# **Final Environmental Statement**

related to the operation of  
Beaver Valley Power Station,  
Unit 2

Docket No. 50-412

September 1985

Figure 4.2 Exclusion area

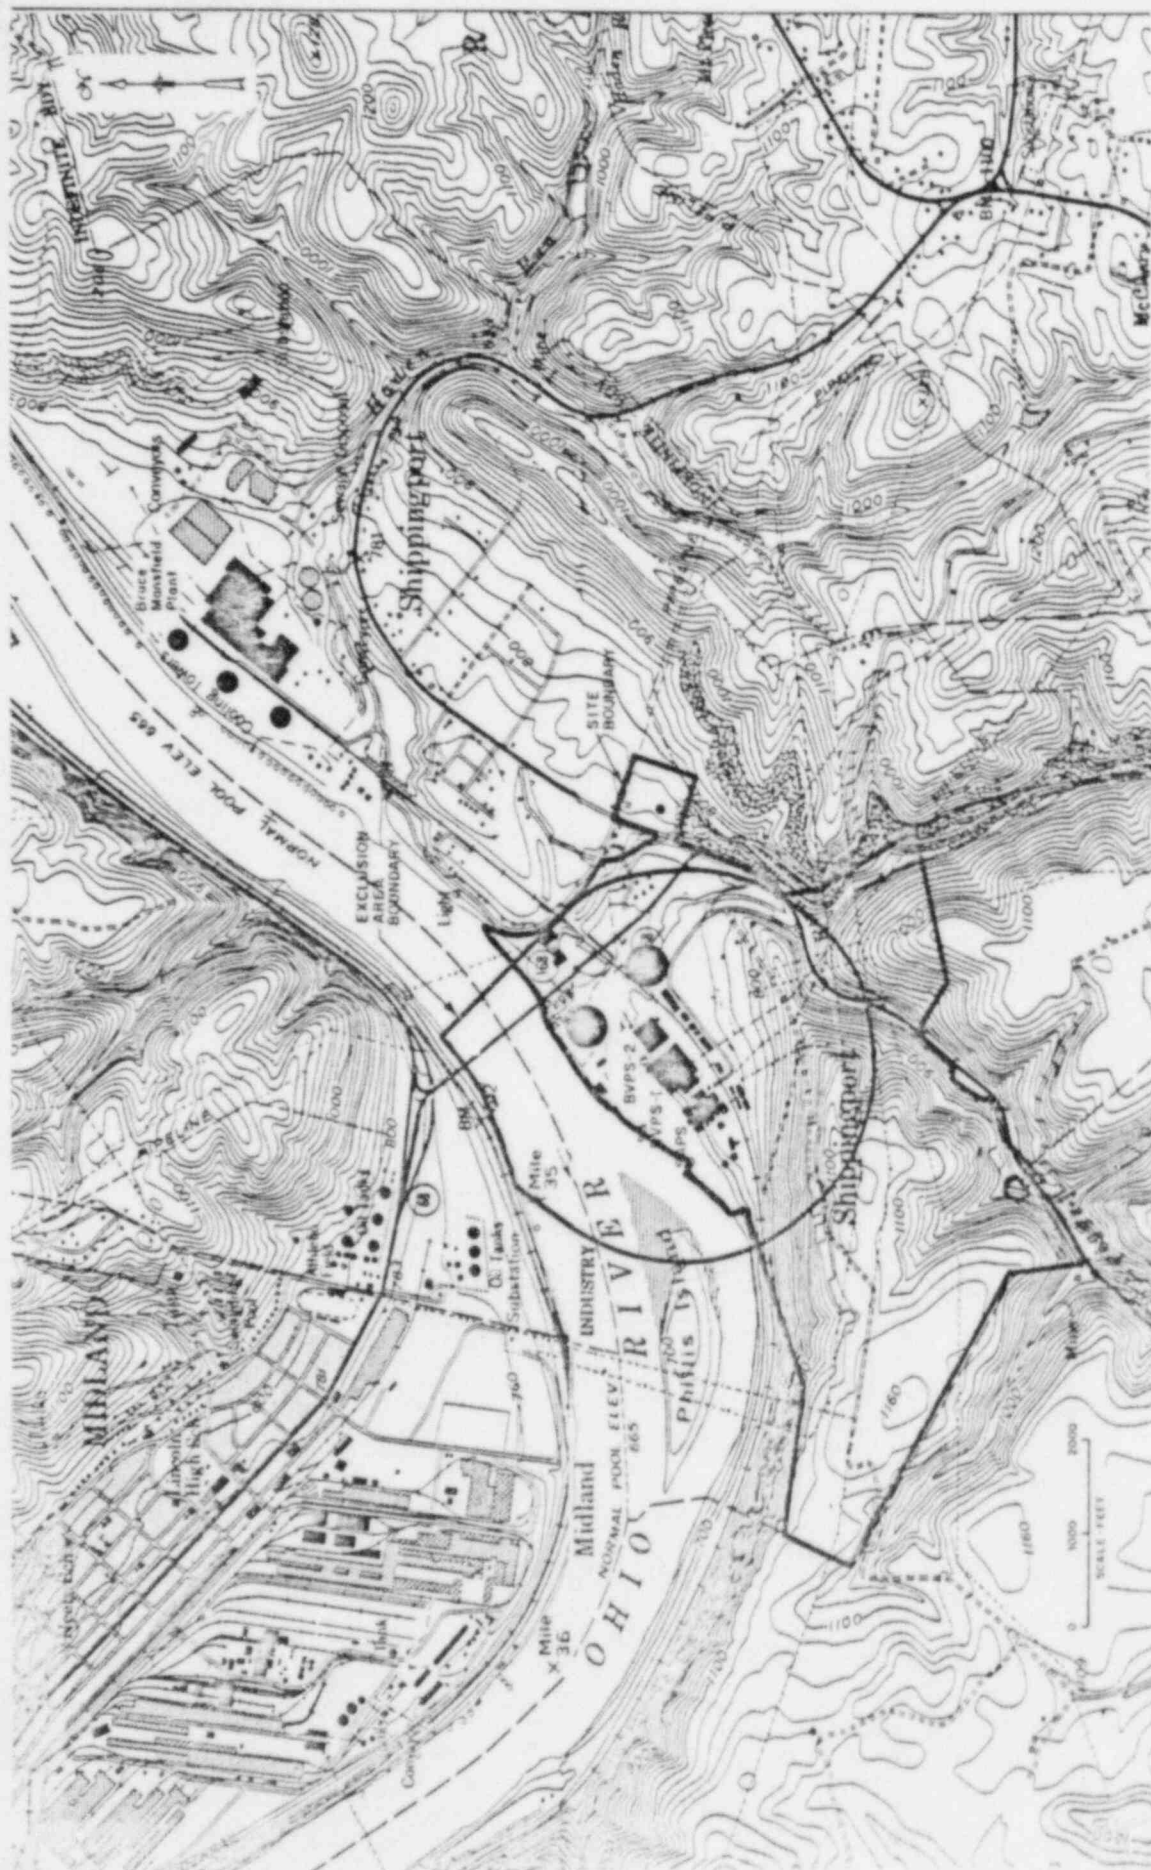
The applicant notes that Figure 4.2 should be revised to reflect the EAB change addressed in DLC-3.

Figure 4.2 has been revised to reflect this comment. The text in Section 4.2.2 also has been restated to be consistent with the FSAR.

Figure 5.10 Isopleths of risk of early fatality per reactor-year to an individual (to convert mi to km, multiply values shown by 1.6093)

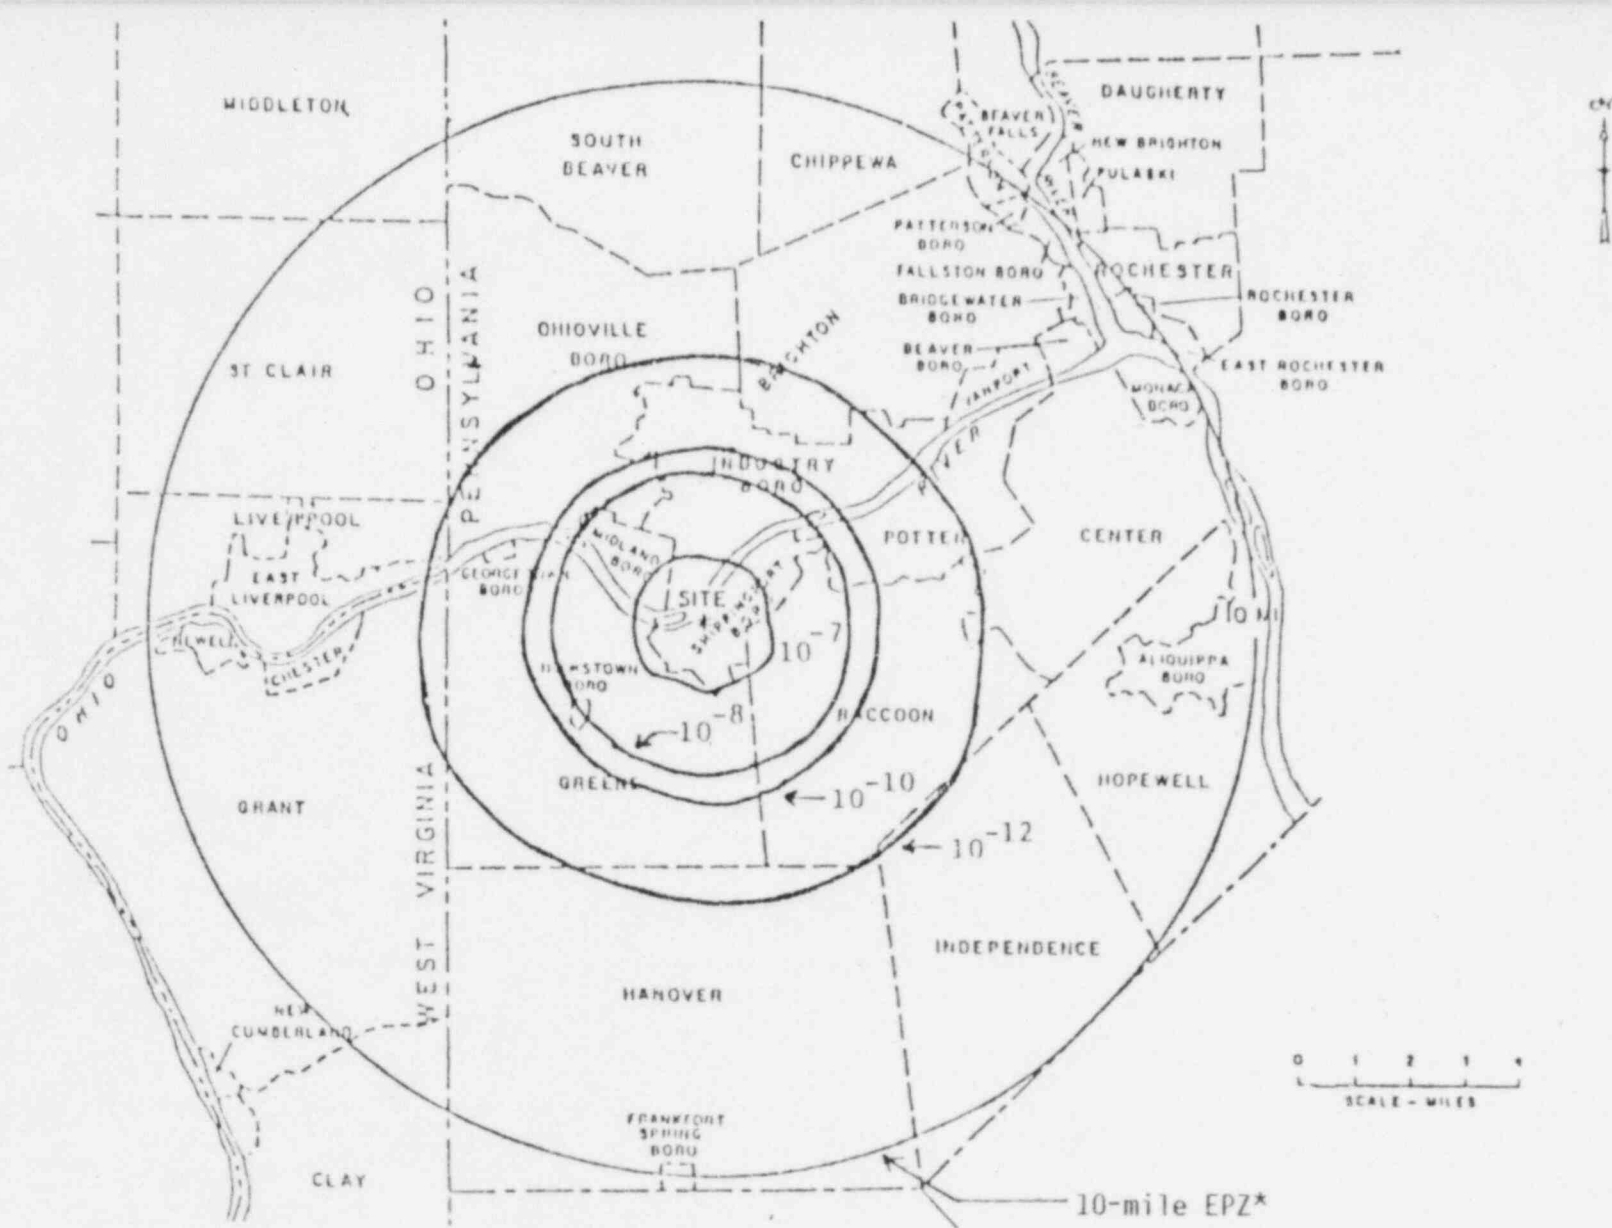
5-57	5.14.2		The NPDES permit was issued on November 26, 1984.
5-73 and 5-74	Fig. 5-10 Fig. 5-11		Although BVPS uses a "10 mile EPZ," the actual EPZ boundary follows various natural and political boundaries located approximately 10 miles from the site. The BVPS Emergency Preparedness Plan contains the detailed information on the EPZ.

The staff acknowledges the actual EPZ boundaries. The 10-mile circular EPZ boundaries shown on Figures 5.10 and 5.11 are for illustrative purposes. They are intended to allow the reader a better visualization of the risk isopleths for early fatality and latent cancer fatality, as indicated by the footnotes on revised Figures 5.10 and 5.11.
